CITY OF ALBUQUERQUE

RE: **UNM Starbucks and Freddie's**
2550 Central SE
Grading and Drainage Plan
Request for Temp C.O. – Accepted
Engineers Stamp Date 2/22/17 (K16D075)
Certification dated: 1-10-18

ENGINEER'S SEAL	STARBUCKS/FREDDY'S	DRAWN BY WCWJ
	GRADING AND DRAINAGE PLAN	DATE 2-22-17
		21702-LAYOUT-1-16-17
DAVID SOULE P.E. #14522	 1606 CENTRAL AVENUE SE SUITE 201 ALBUQUERQUE, NM 87106 (505) 872-0999	SHEET #
		JOB # 21702

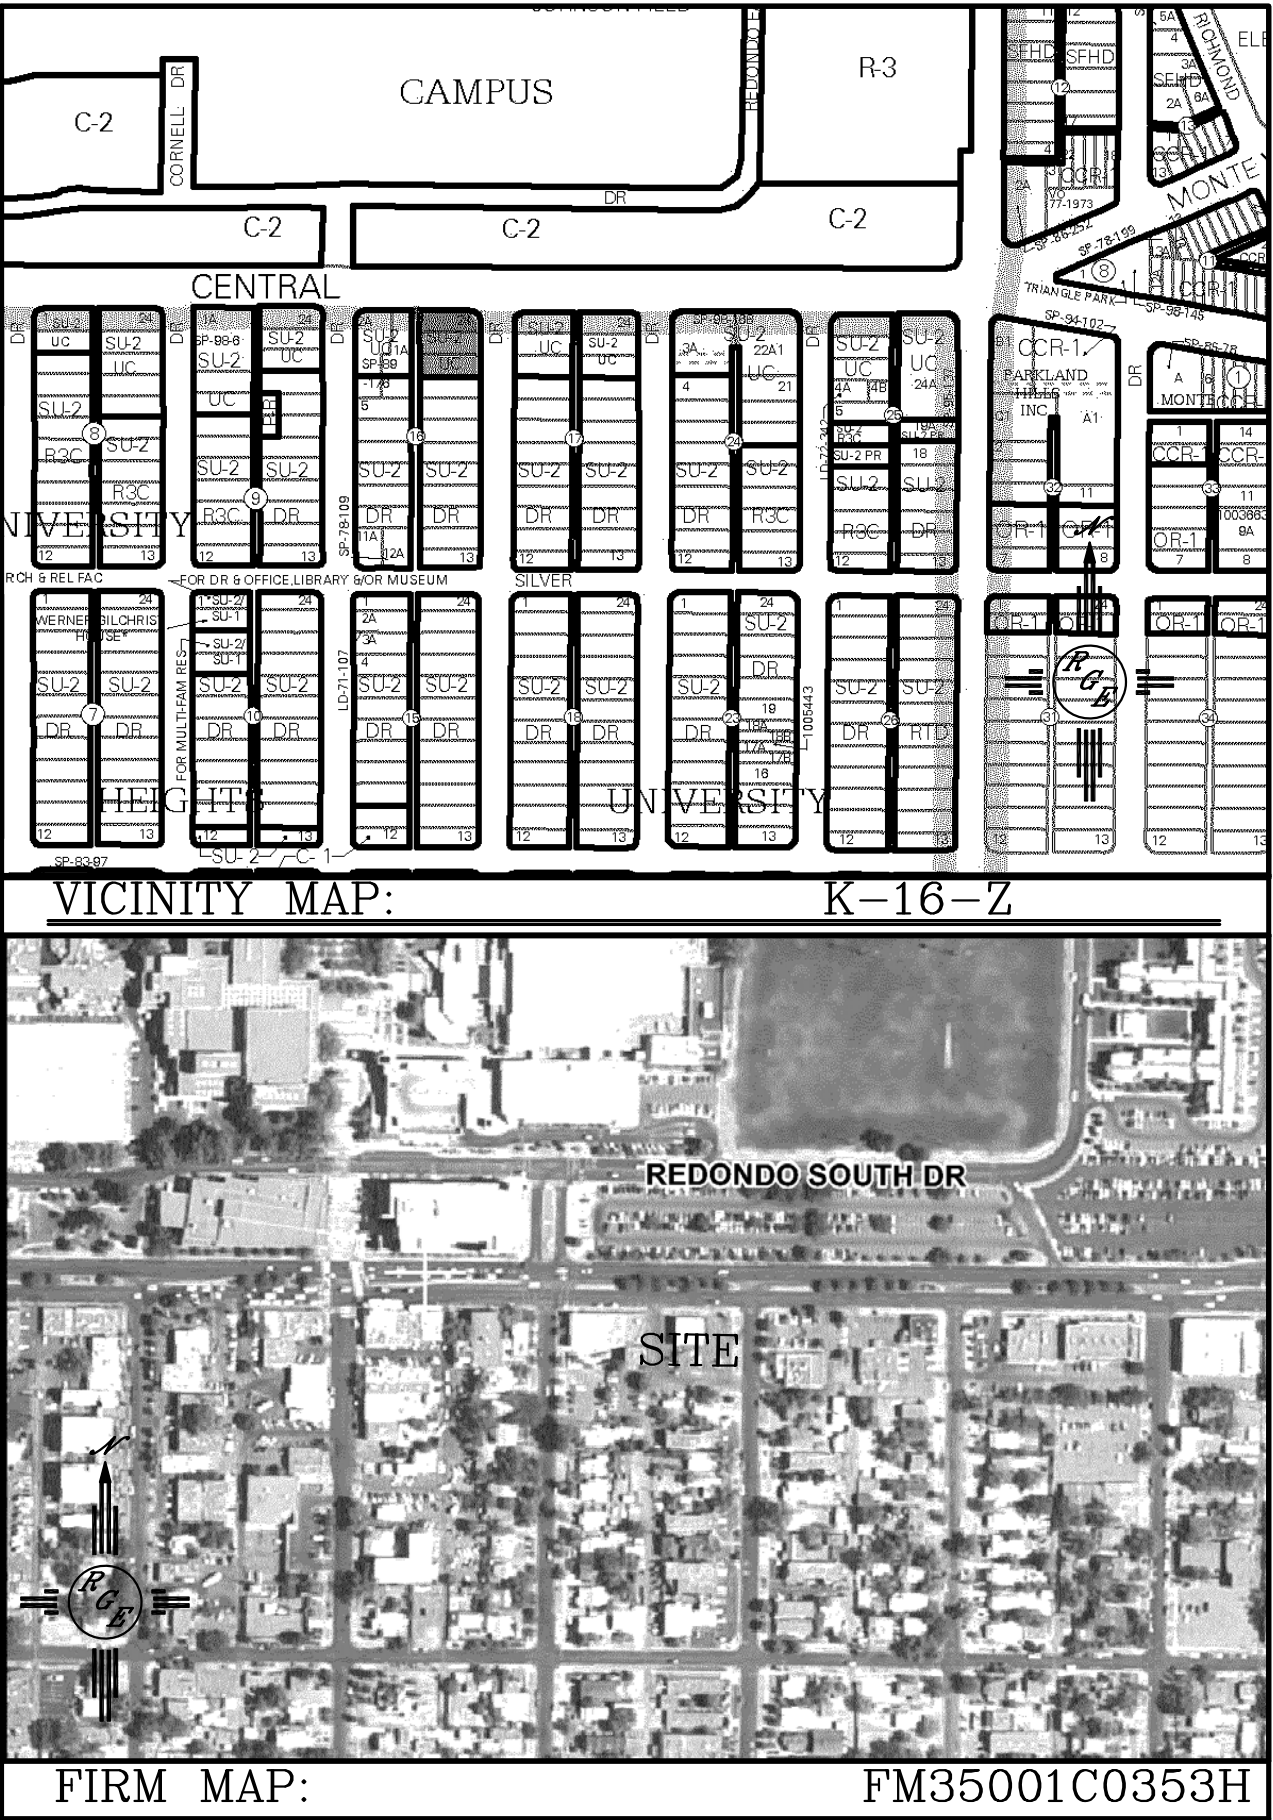
- Sidewalk culvert should be constructed per the plan.
